Project: 08-25-3311 HCA LSMC CAMPUS EXPANSION
2100 SE BLUE PARKWAY
LEE'S SUMMIT, Missouri 64063

RFI #026: Pedestrian Bridge Footings

1 TYPICAL SECTION AT STEEL BEAM / RET. WALL

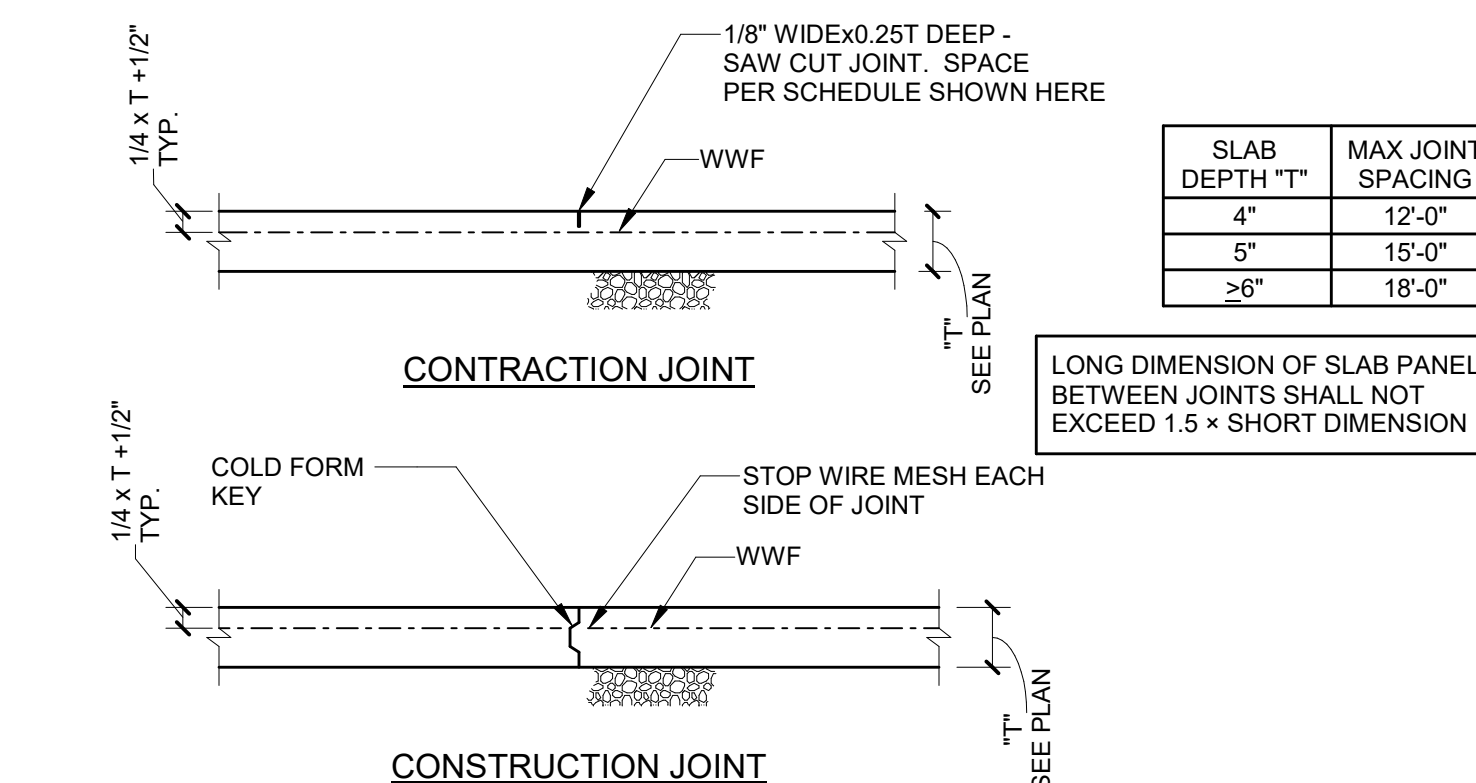
Q: THROUGHOUT THE PLANS, THERE APPEARS TO BE NO DETAILS OR SECTIONS IDENTIFYING THE LENGTH AND WIDTH OF THE PEDESTRIAN BRIDGE FOOTINGS. CAN ARCHITECT PLEASE PROVIDE SECTION OR DETAIL DEFINING THESE DIMENSIONS. -
NAB-MF-06.30.2025

Provide the foundations 4'-0" wide. See the markups on detail 1/S211 for the length of the foundation. -SDL

2 PEDESTRIAN BRIDGE SECTION

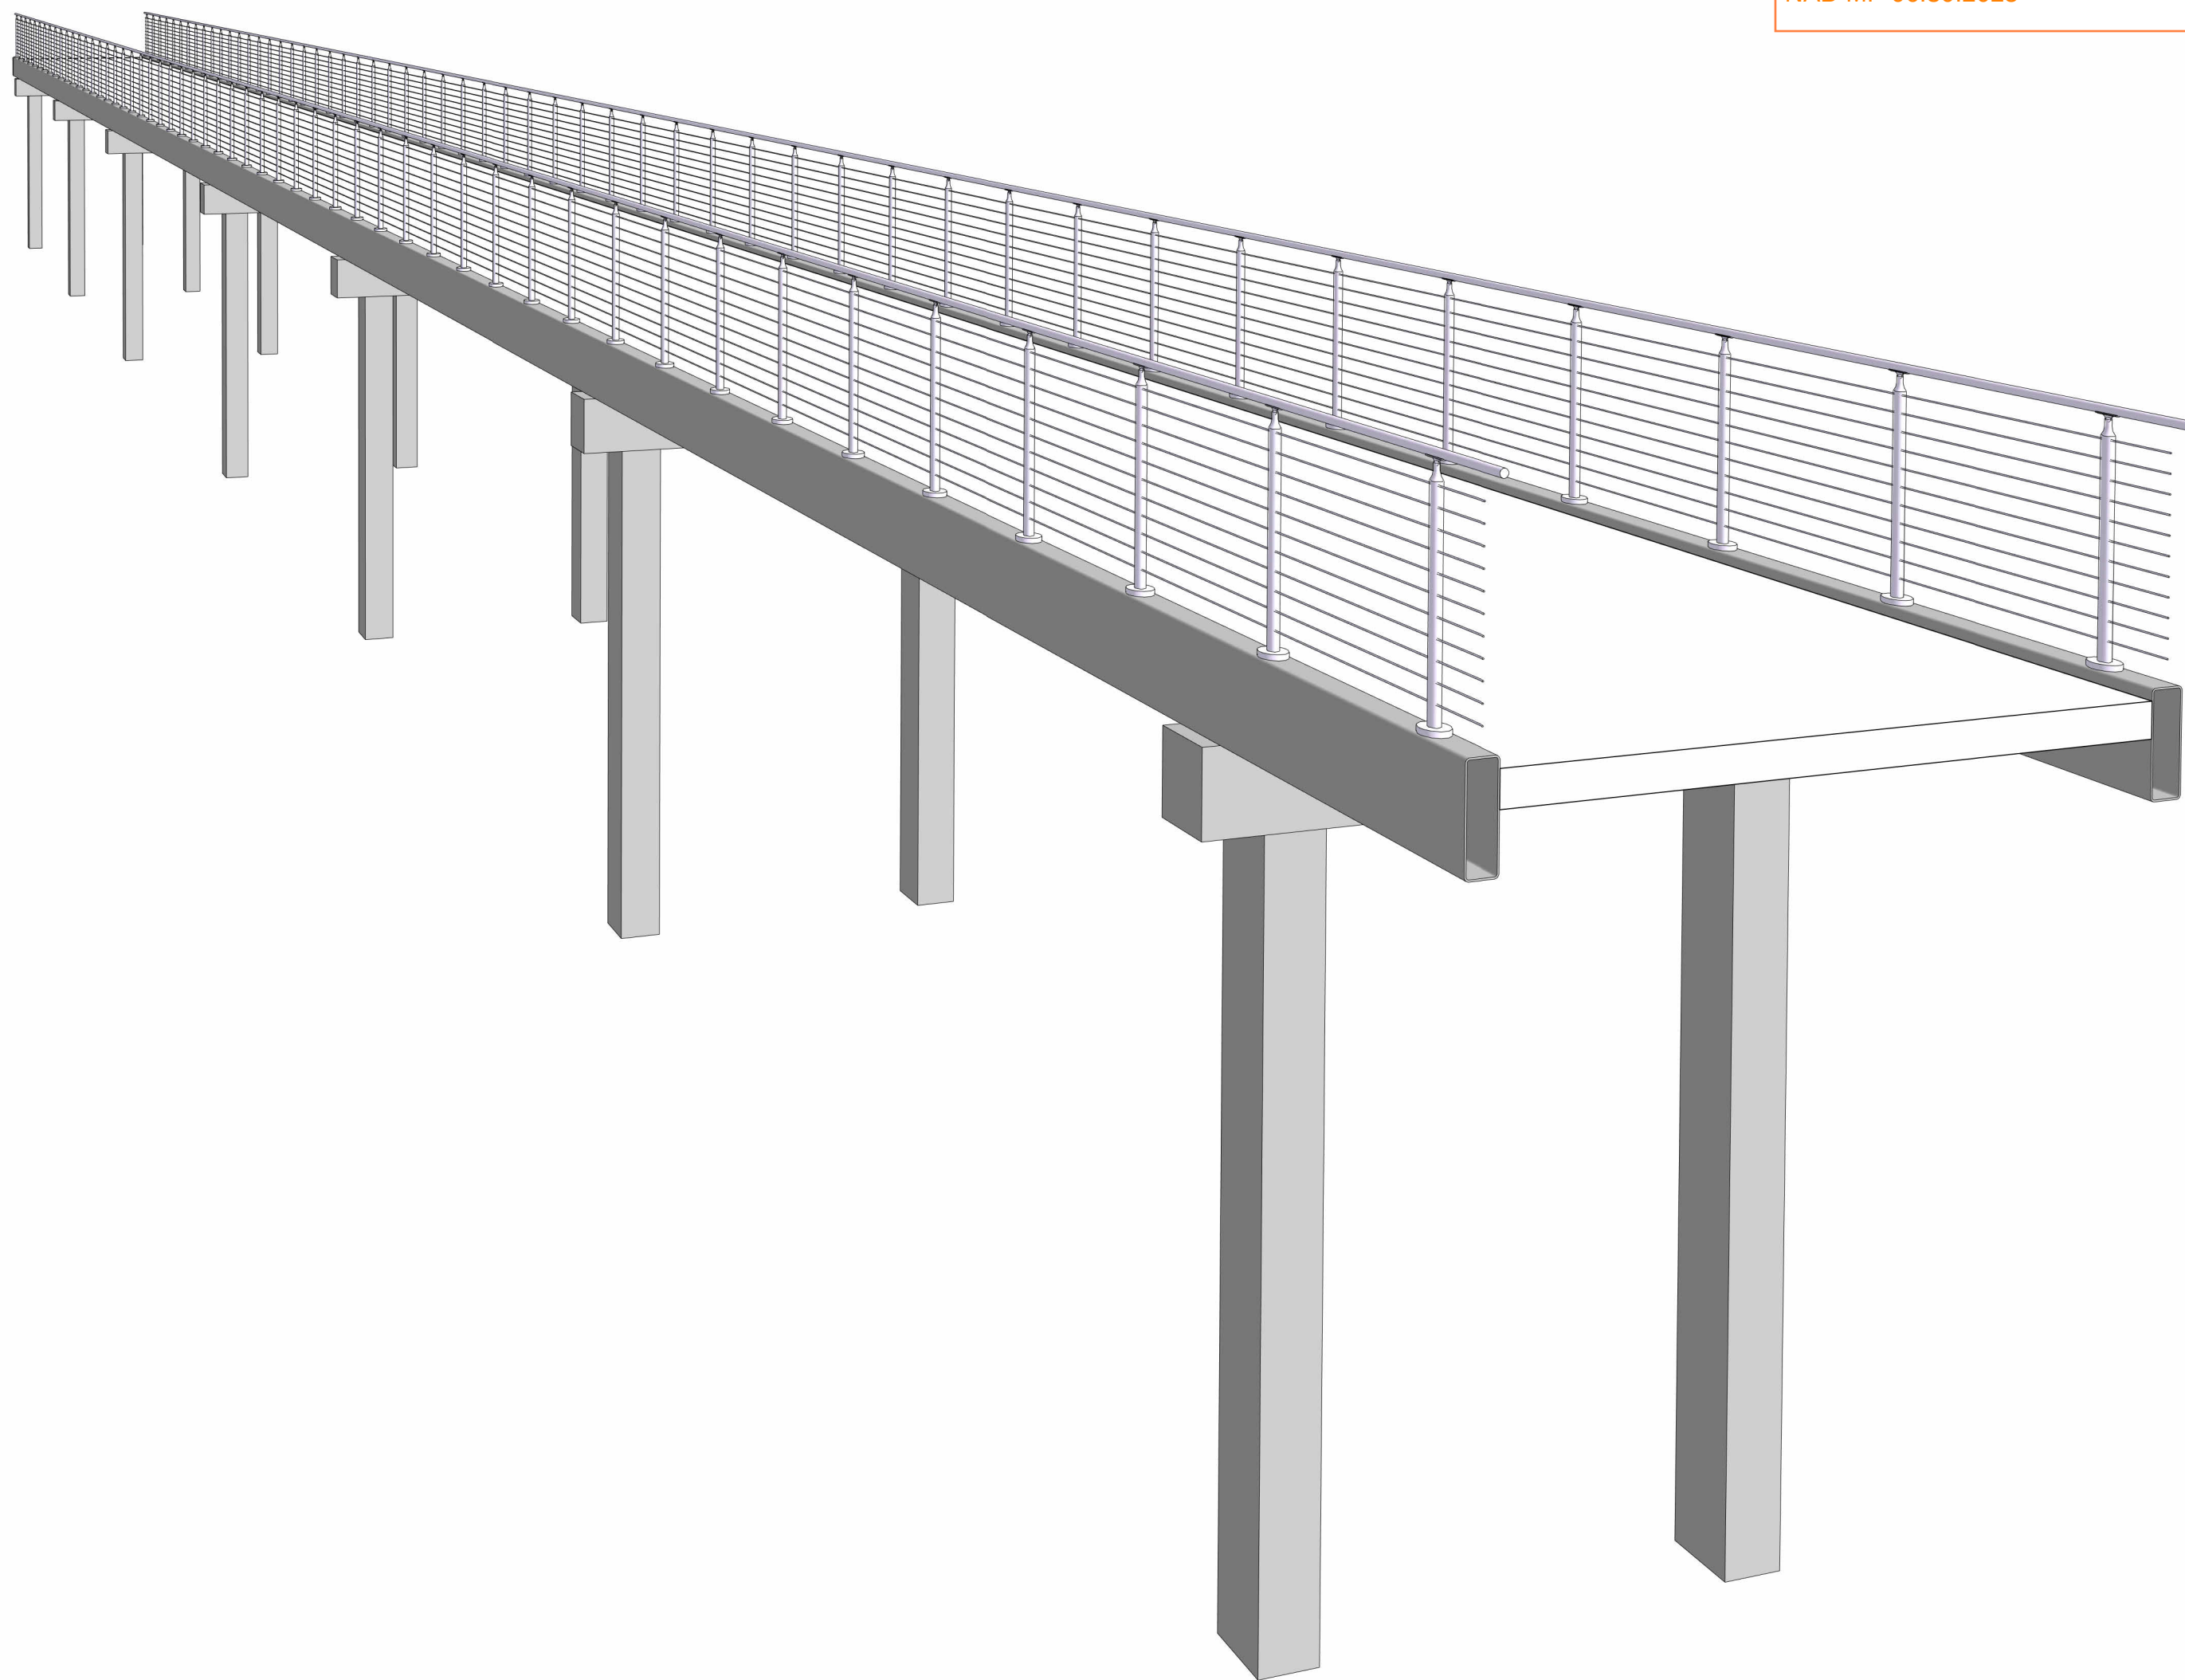
SECTION DETAIL REFERENCES THE STRUCTUAL DRAWINGS FOR DETAILS ON THE PEDESTRIAN BRIDGE FOOTINGS, HOWEVER, NO STRUCTURAL DETAILS DEFINE THE FOOTINGS LENGTH AND WIDTH. - NAB-MF-06.30.2025

See the markups in the RFI document. The width of the foundations is to be 4'-0". The length of the foundation is to be 2'-0" on either side of grid lines BA and BC.
